Project Number: SP2018-014

Job Address: 6519 HORIZON RD

RE: SITE PLAN (SP2018-014), See Conditions -- Woodhill Dental

SP2018-014 Site Plan for Woodhill Dental: Please address the following comments (M= Mandatory Comments; I = Informational Comments)

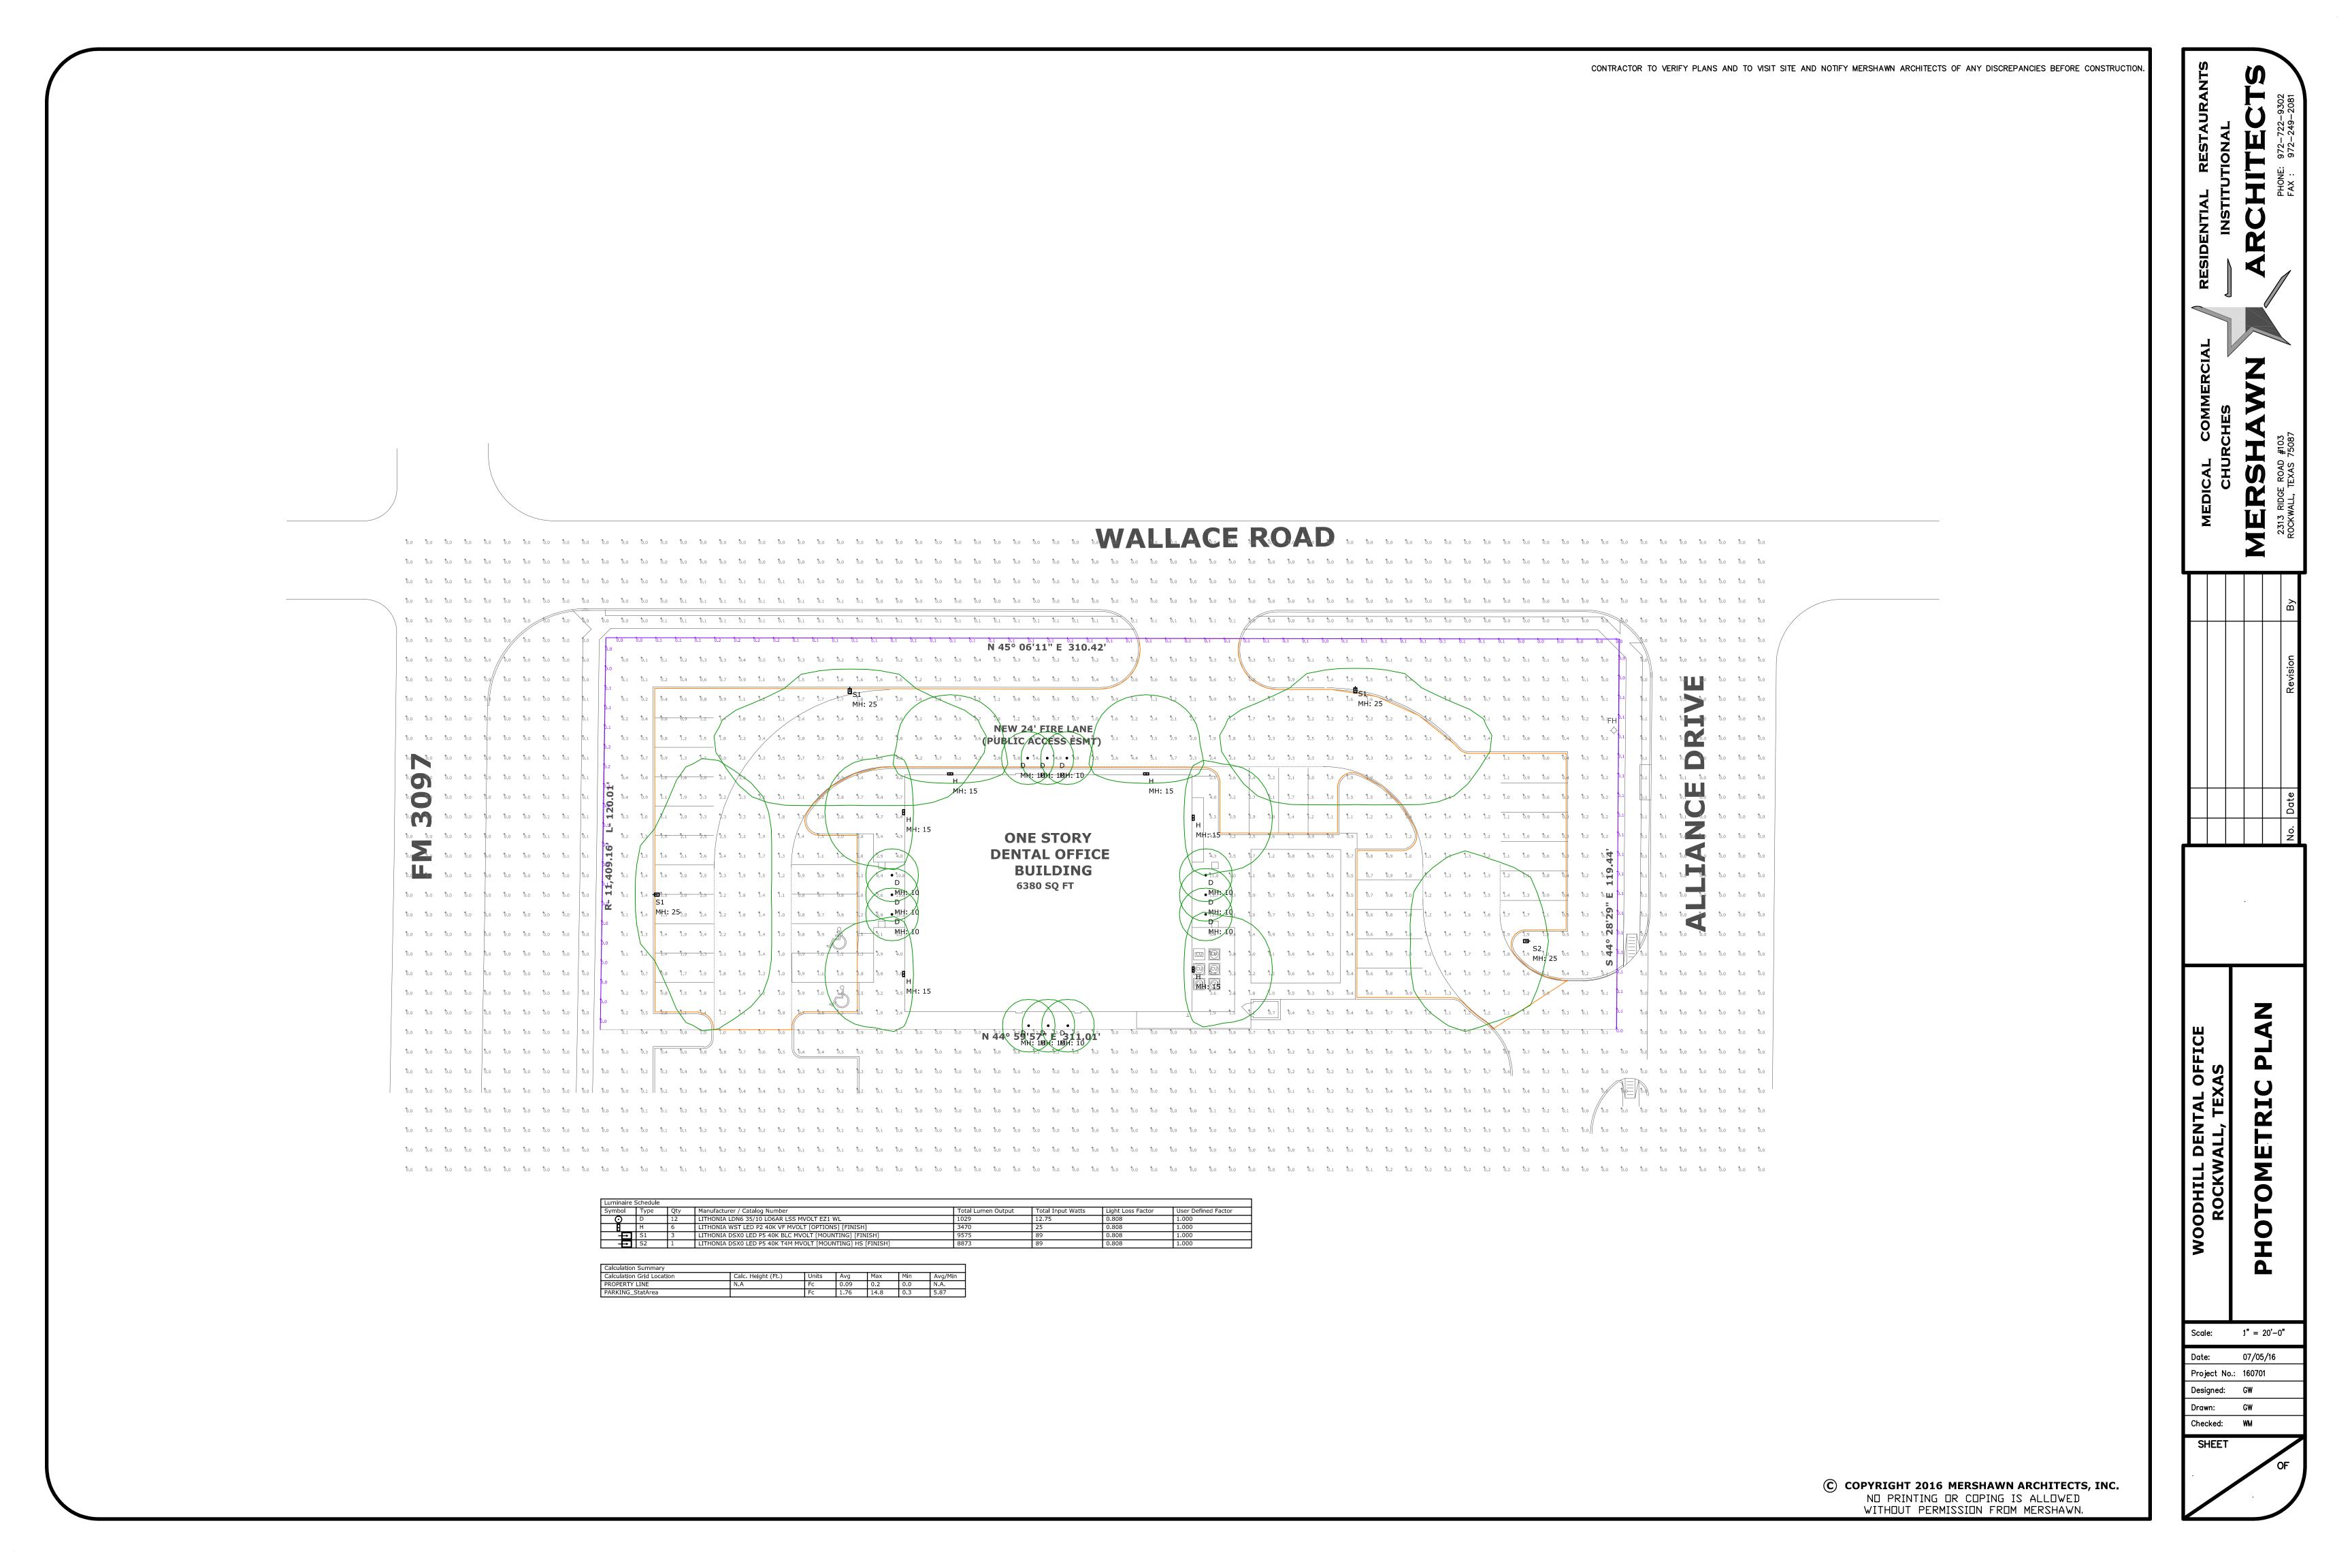
- M.23 Site Plan. Please note that the required parking is 31 spaces.
- M.24 Landscape Plan. Please see PD-57 requirements for living screen adjacent to Wallace Lane.

- M.25 Landscape Plan. Please show and label easements.
- M.26 Landscape Plan. Please show centerline for all adjacent roadways
- M.27 Photometric Plan. Please darken property line on photometric plan.

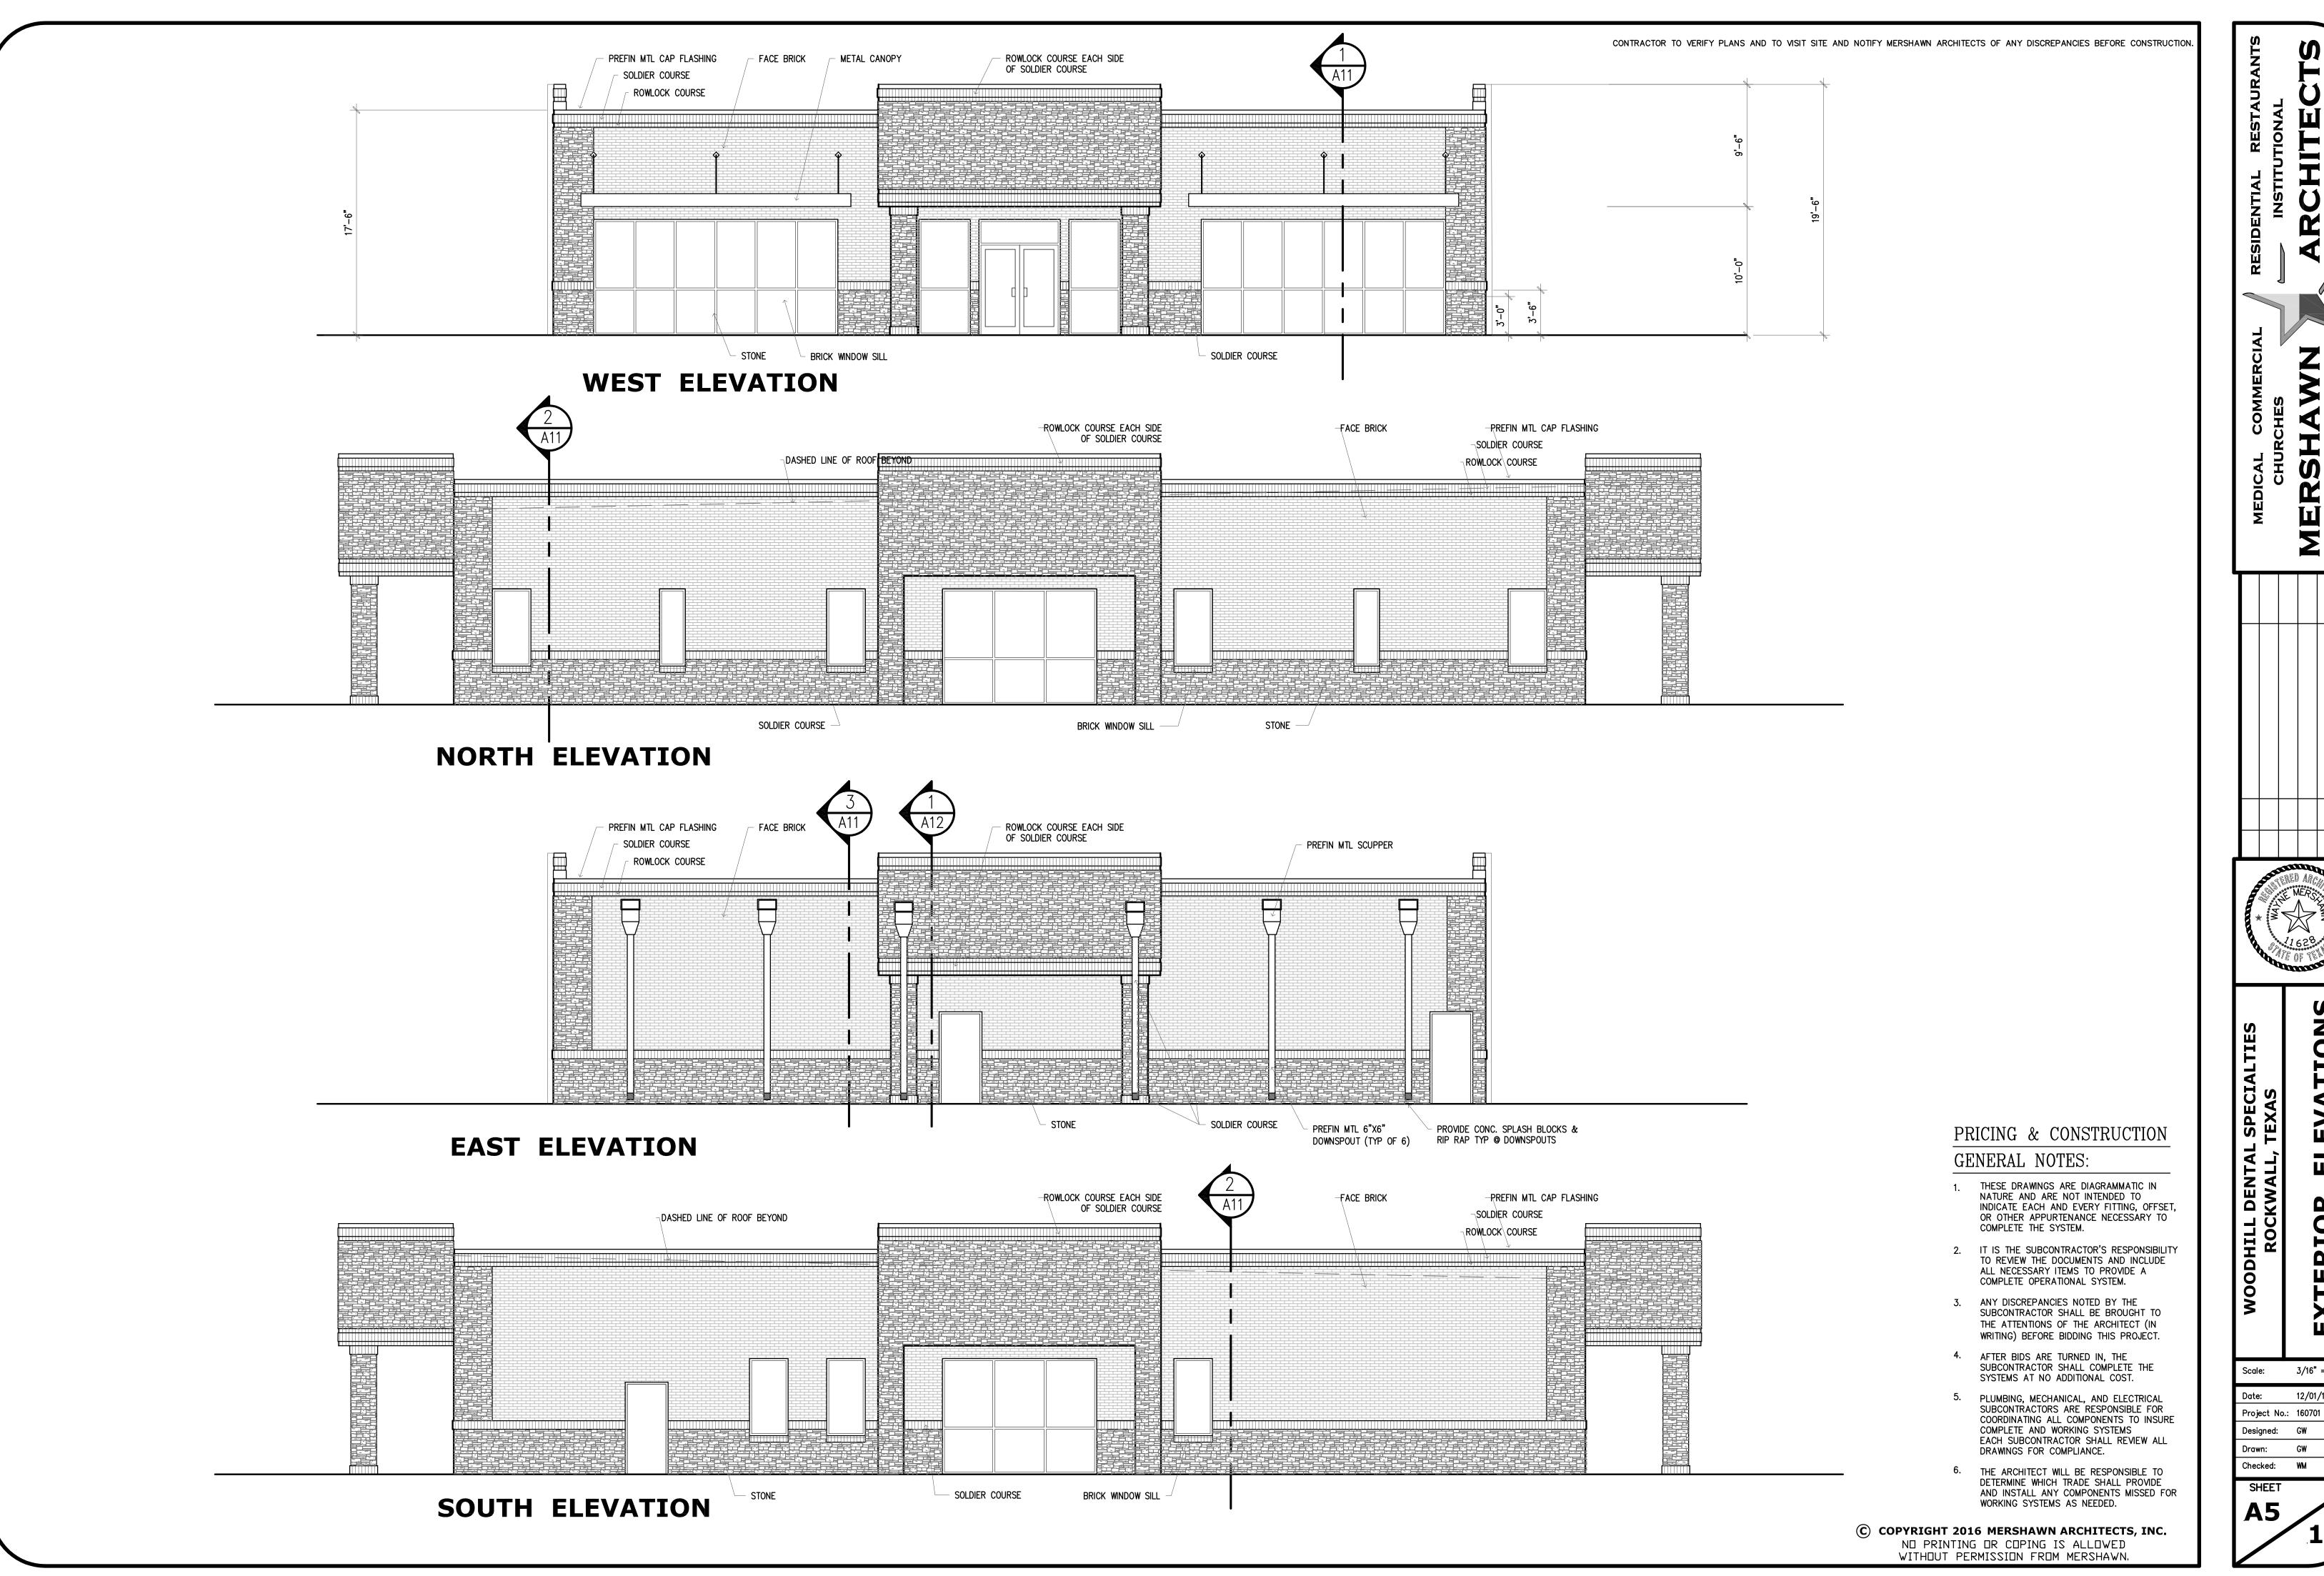
- M.6 Site Plan. You will need to reserve an addition 10-feet for your landscape buffer adjacent to FM 3097 to allow for the future expansion of FM 3097.

- M.7 Site Plan. Please dimension all walls of the building.
- M.8 Site Plan. Please show distance from the property line to the building for each side.

- M.9 Site Plan. Please dimension a typical parking space.
- M.10 Site Plan. Please hatch firelane and provide paving material and depth
- M.11 Site Plan. Please provide paving material and thickness.

- M.12 Site Plan. Please show centerline of FM 3097, Wallace Road, and Alliance Drive.
- M.13 Site Plan. Please note that rear setback is 10-feet unless fire retardant wall.

- M.14 Site Plan. Please add note to dumpster that it has an opaque, self-latching gate
- M.15 Site Plan. Please note that the minimum size for dumpster enclosure is 10 x 12.

- M.16 Site Plan. Please indicate screening of pad mounted equipment
- M.17 Site Plan. What is the rectangle to the right of the building? Please label.

- M.18 Site Plan. Please hatch sidewalk.
- M.19 Site Plan. Please review the PD-57 standards, as this building does not seem to follow the theme of theothers.

- M.20 Site Plan. Please note, the setback along Wallace Road and Alliance Drive is 15-feet. This lot has triple frontage. The front yard setback is 15-feet for a Commercial (C) District. The 25-foot setback adjacent to FM 3097 is correct because you will need to reserve 10-feet for future expansion.

- M.21 Site Plan. Please provide square footage of the site next to the acreage that is shown within the footprint of the building.
- M.22 Site Plan. Please provide site data table as shown on the submitted Landscape Plan.
